Groundwater Application Review Summary Form

Application # G- 18846

SUBJECT: Scenic Waterway Interference Evaluation

TO: Water Rights Section Date 2/17/2023
 FROM: Groundwater Section Travis Brown
 Reviewer's Name
 SUBJECT: Application G- 18846 Supersedes review of 8/3/2020
 Date of Review(s)

Stream-Depletion Model Results

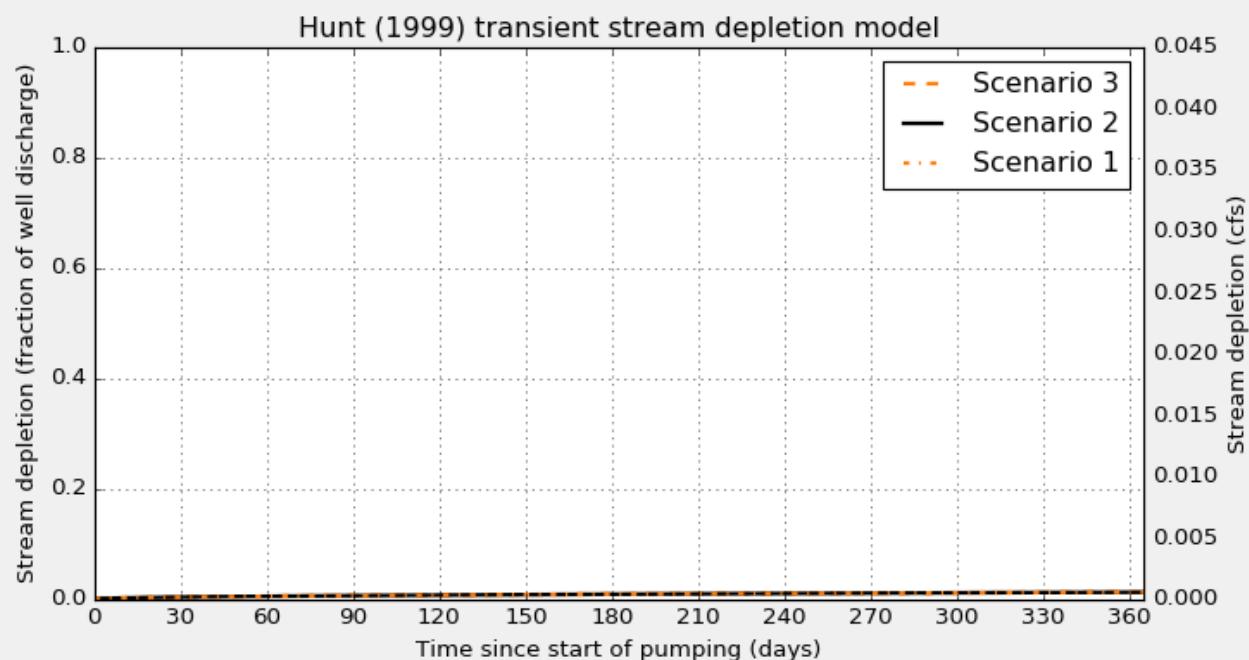
Comments: Stream-depletion was estimated using the Hunt-1999 stream-depletion model with hydraulic parameter values in a range of expected values for the local aquifer system, informed by nearby pump-test data.

- C6. **SW / GW Remarks and Conditions:** The applicant's proposed POA would be producing from an aquifer system that has been found to be hydraulically-connected to surface water, specifically Bear Creek and Papenfus Creek; the proposed rate and estimated stream-depletion are below the criteria where Potential for Substantial Interference, per OAR 690-009, must be assumed.
